STAFF REPORT: REGULAR CALENDAR

APPLICATION NO.: 4-95-103

PROJECT LOCATION: 1 State Street, City of Santa Barbara along southern bank of Mission Creek between Mason Street and State Street bridges.

PROJECT DESCRIPTION: As built +/- 115 ft. long timber retaining wall, 20 timber piles with 3" to minus fill gravel, 18" – 24" 4 sack slurry underlain with 6" concrete as backfill within channel of Mission Creek. The retaining wall was constructed as an emergency action to replace a section of an existing timber retaining wall which was destroyed as a result of high storm flows and flooding on lower Mission Creek in January 1995. The new structure encroaches up to 10 feet further into the active channel of the creek beyond the location of the destroyed retaining wall.

SH 1 OF 2
FLOOD DAMAGE REPAIR DATE 5-24-95

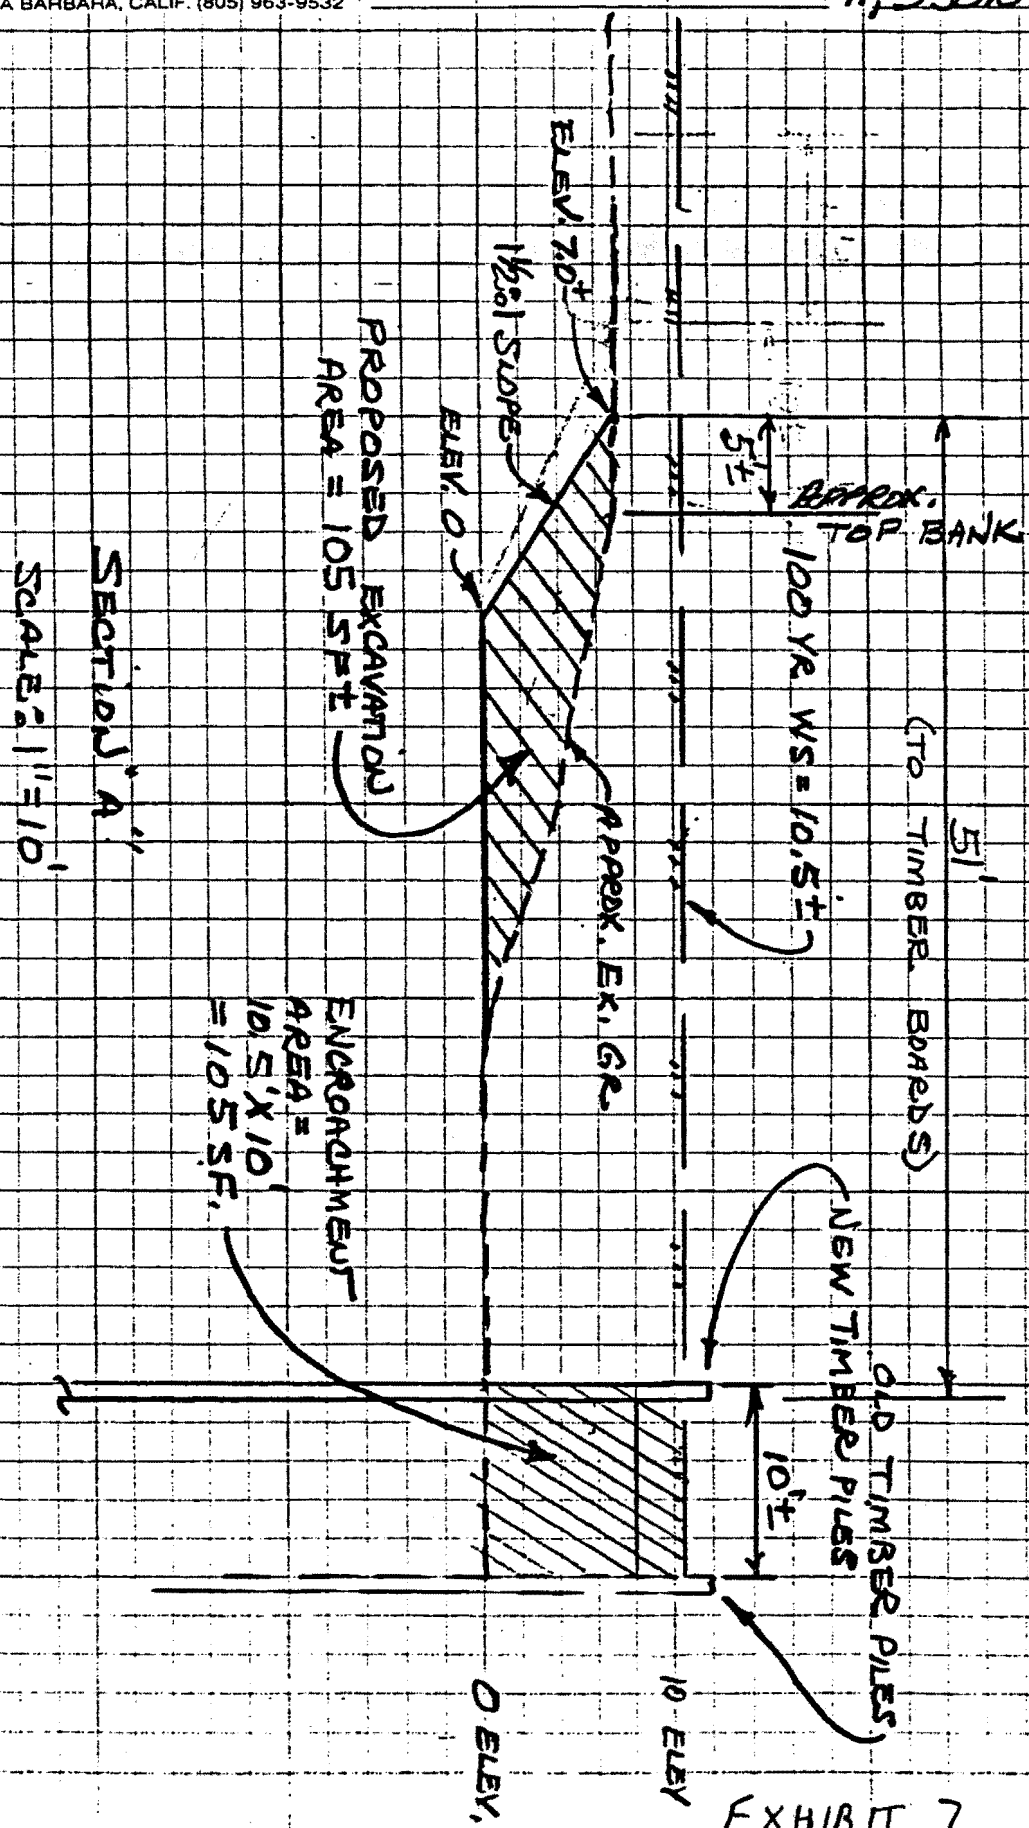
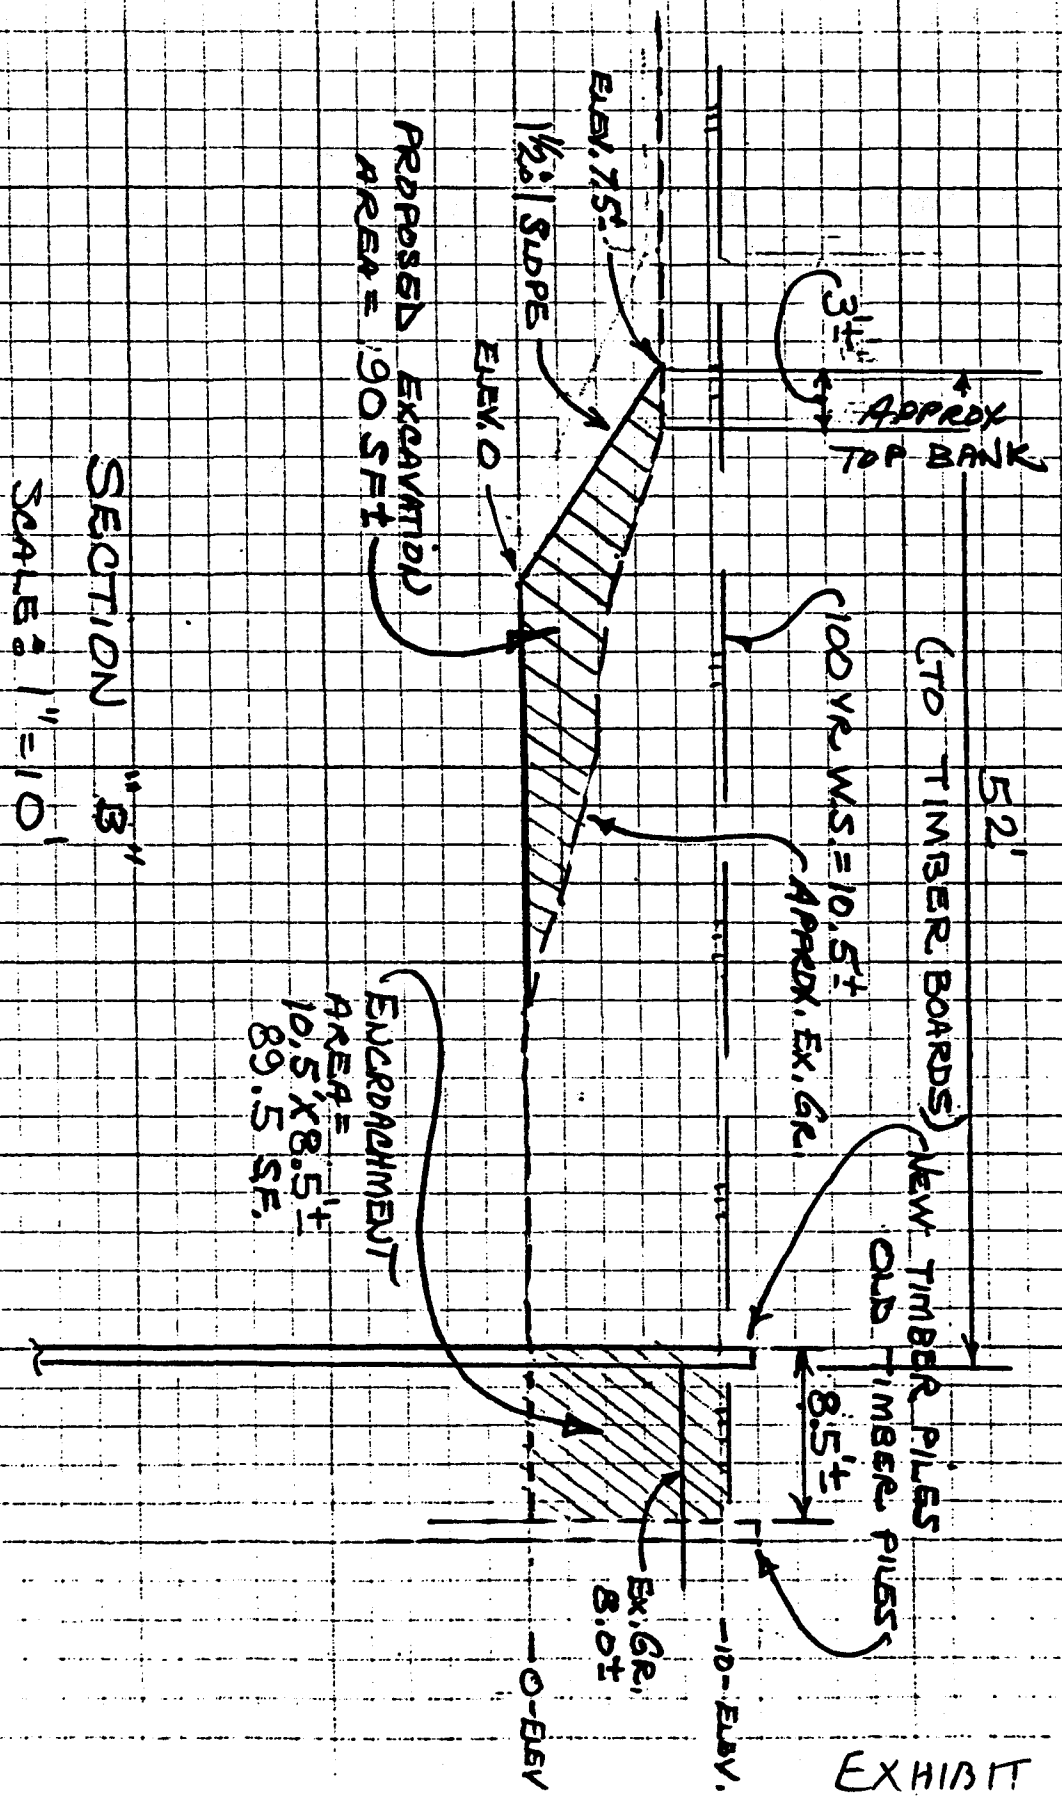
This conclusion assumes, however, that the excavation would remain open. Given the location of the proposed location on the inside bend of a meander loop, deposition might be expected at this site during low and moderate flows. Meandering rivers typically deposit sediment on the inner bank of meander loops, forming a point bar and erode the outer bank, leading to the type of erosion that damaged the previous timber wall. Although bank-full discharge might be expected to erode some of this material, the initial flood could occur in a channel of reduced capacity. Thus, more information concerning the nature of point bar dynamics at the subject site is necessary before the proposed mitigation can be fully evaluated.

In addition, examination of the site plans (reference 3) and photos indicates that the natural meander curvature has been altered by the encroaching timber wall. This suggests that the thalweg (line of maximum velocity) might be deflected away from its natural position near the outer bank of the meander loop, and more towards the left bank downstream of the project site. Such a deflection could induce erosion near the northern abutment of the State Street Bridge. I recommend that this potential be fully evaluated before an after-the-fact permit be approved.

The project area is not therefor considered "floodway." However, we recommend that an area along the opposite side of the creek be excavated to provide approximate equivalent conveyance. Enclosed herewith are a plan and sections defining the proposed excavation. The following are comments regarding the plan.

5. The quantity of material to be excavated is approximately 400 cubic yards.
6. Sections A & B show that the cross sectional area of the proposed excavation will approximately equal the cross sectional area of the encroachment. Both the manning's roughness coefficient and the hydraulic radius for the sections would be approximately the same for the before and after condition. Therefore equivalent conveyance would be achieved.

It is therefore my opinion that if the excavation is completed as shown on the plan, approximate equivalent conveyance will be provided.
